From: Iksun Yang
To: c.campbell.architect
Cc: kimmunro362@gmail.com
Subject: RE: BCO10364430-A, 362 Matakana Valley Road Matakana - 1st RFI follow up
Date: Thursday, 23 May 2024 9:54:00 am
Attachments: image001.png
image002.png

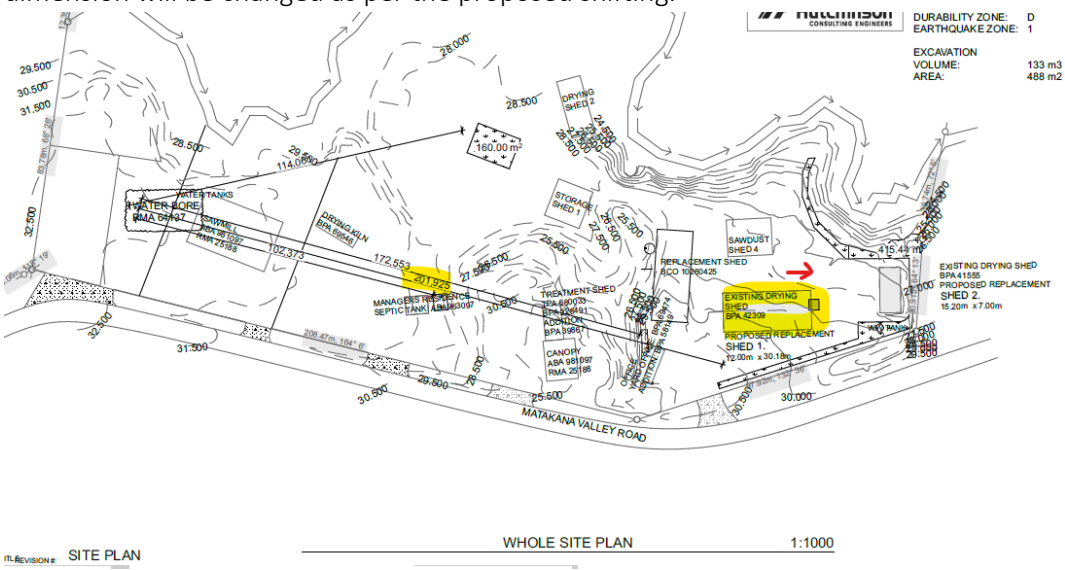
As per the approved site plan, the siting dimensions indicated on sheet 100 and 101. And the dimension will be changed as per the proposed shifting.

So, the siting dimensions on sheets 100 and 101 need to be updated.

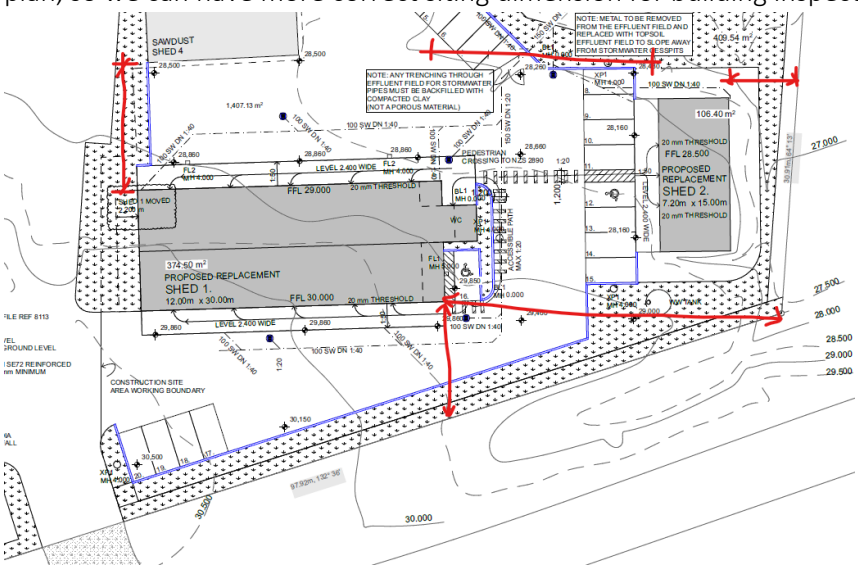
Or alternatively, you can add some siting dimensions on sheet 01.1 as this is the enlarged site plan, so we can have more correct siting dimension for building inspectors.
